# UNITED STATES PATENT AND TRADEMARK OFFICE

APPLICATION NO.	FILING DATE	FIRST NAMED INVENTOR	ATTORNEY DOCKET NO.	CONFIRMATION NO.
10/074,362	02/12/2002	Brian N. Tufte	1076.1101106	9078

# Office Action Summary

## **DETAILED ACTION**

Part of Figure 38 of the instant application (a) and Figure 4 of Newman (b). Newman's figure has been modified to designate elements corresponding to those of the claimed invention using the same reference numbers used by the applicant.

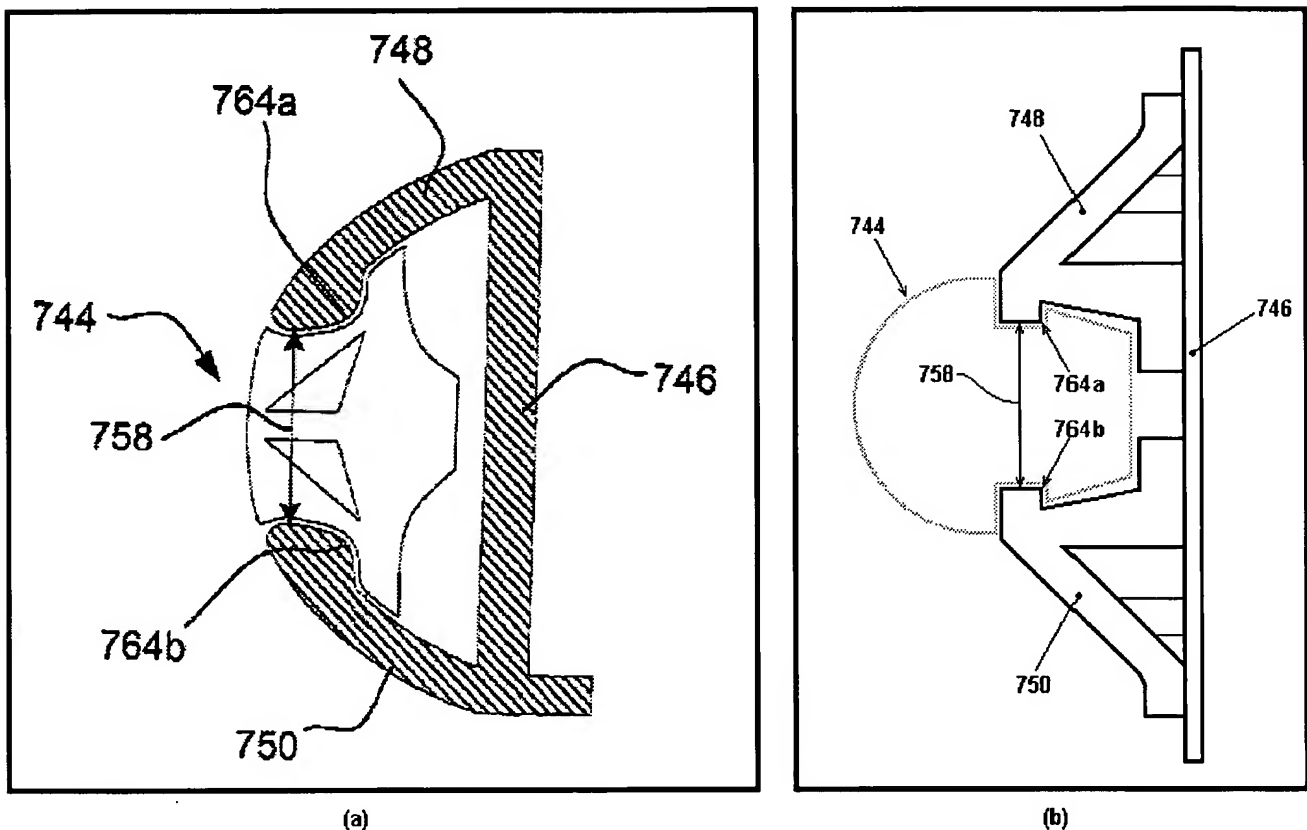
9. Regarding the Examiner's rejection of claims 1, 11 and 14 under 35 U.S.C. 102(b), the applicant argues that the cited reference fails to disclose all the features of the claimed invention, specifically the two terminating ends defining the slot, as well as an inwardly extending nub.

To clarify the Examiner's interpretation of Newman the applicant is advised to study Figure 4 of Newman in view of applicant's own Figure 38. For applicant's convenience the Examiner has modified the cited figures to show only the relevant

by the applicant. As it is evident, both applicant's Figure 38 and Newman's Figure 4 show a bumper member (744) and a carrier (742) having a pair of supporting legs (748 and 750). The supporting legs having nubs (764a and 764b) located at each end. A slot (758) is defined by the ends of the supporting legs. The only difference between both structures is the use of rounded edges by the applicant, as opposed to Newman's rather square edges.
